**Environmental Impact Statement (EIS) assessment report
under the *Environmental Protection Act 1994***

Central Queensland Coal

proposed by Central Queensland Coal Pty Ltd and
Fairway Coal Pty Ltd

Prepared by: Environmental Impact Assessment, Department of Environment and Science

Figure 5 Proposed final landform

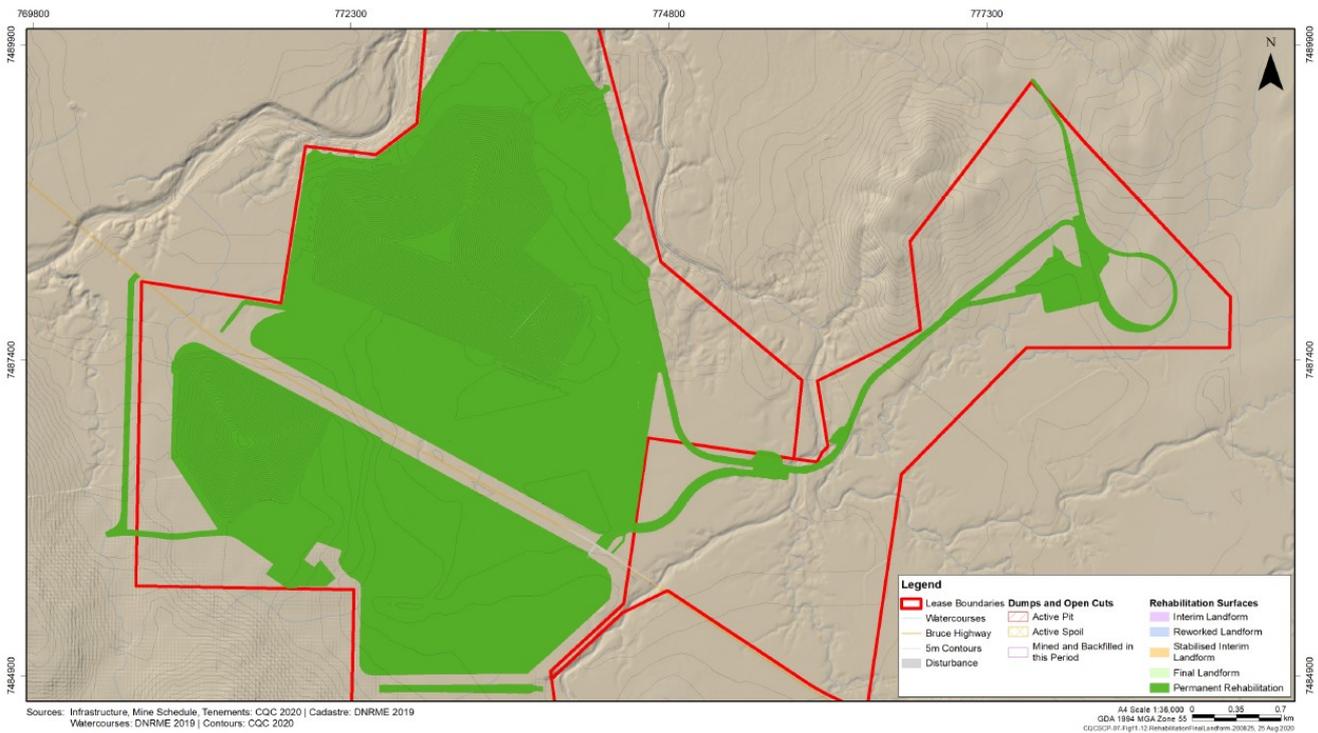
However, the EIS does not provide any specific details about the rehabilitation and need for on-going maintenance of these diversion drains. The rehabilitation indicator for the diversions is that they meet approved design criteria, but no relevant completion criteria were provided in the EIS.

Additionally, the backfilled pit would include reinstated drainage paths to drain local runoff and flow breakouts from Deep Creek, to Tooloombah Creek and Deep Creek. Detailed design of the reinstated drainage paths is required to be carried out to ensure that the final landform is safe, stable and non-polluting in the long-term. The drainage lines are proposed to be vegetated and self-sustaining. I consider that the reinstatement of drainage lines has not been adequately discussed in sufficient detail. Should the project be allowed to proceed, further clarification would be required in any future PRC plan about the location of the Southern Catchment diversion drain in the final landform and its role in achieving the final land use.

More detail would be required in the PRC plan about how the drainage paths would be reinstated in the final landform to achieve the rehabilitation goals. This should not only include consideration of soil, vegetation and hydraulic characteristics, but also water quality.

I note that the waste rock dumps are proposed to have slope angles of less than 7 degrees in order to achieve the goal of stability. However, this may not be sufficient for highly dispersive soil. I note inconsistency in the EIS depicting the landforms that have long gentle slopes on one side and steep slopes on the other. Landform modelling would be a requirement of the PRC plan process to enable the final landform to be designed in such a way that it is safe, stable and non-polluting over the long term.

Figure 6 Groundwater drawdown contours

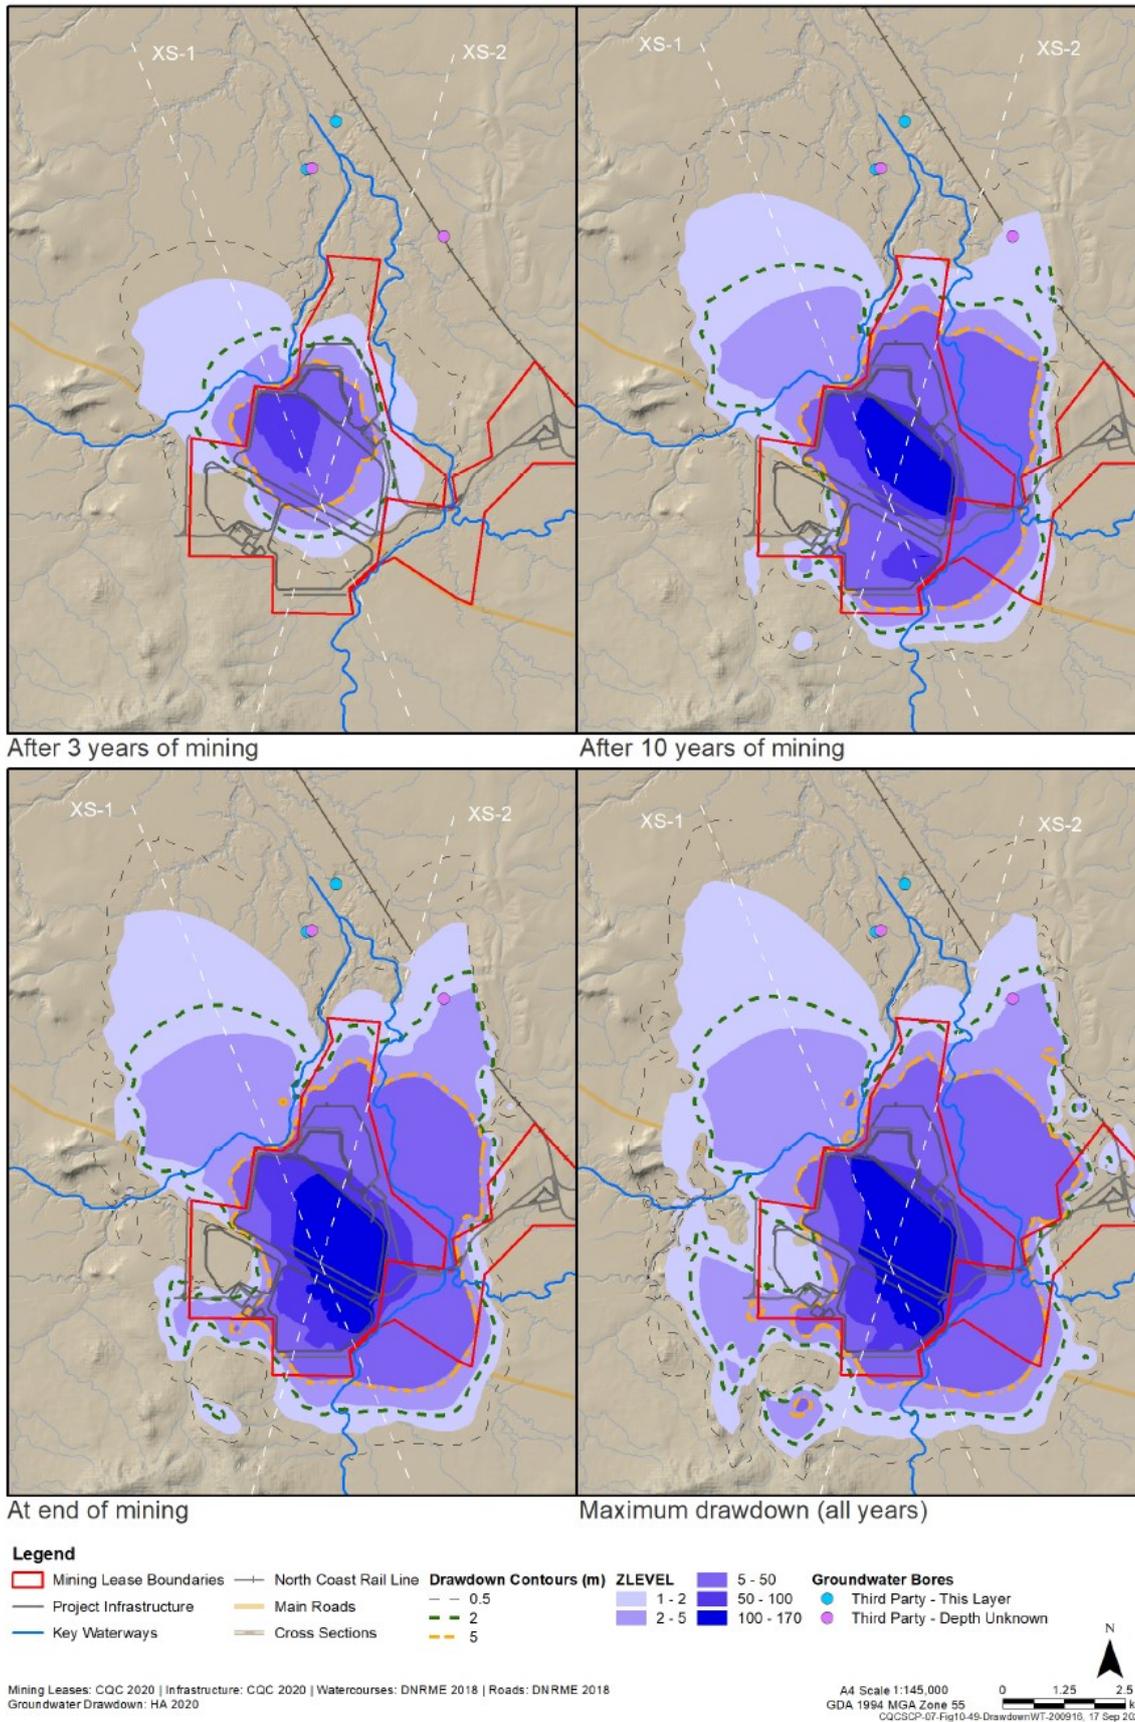
Revised assessments in the amended EIS informed by a new regional groundwater model stated that groundwater drawdown impacts to Tooloombah Creek and Deep Creek would not significantly impact fish habitat values. Observed pools persistence and water quality data indicate that the primary source of baseflow to pools is from bank storage return. Impacts on Tooloombah Creek are expected to be minor due to the predicted drawdown (less than 4m), low permeability sediments reducing the potential for enhanced leakage, flows from bank storage sustaining some pools, and natural resilience of ephemeral pools (particularly on Deep Creek) already experiencing natural drying cycles under baseline conditions.
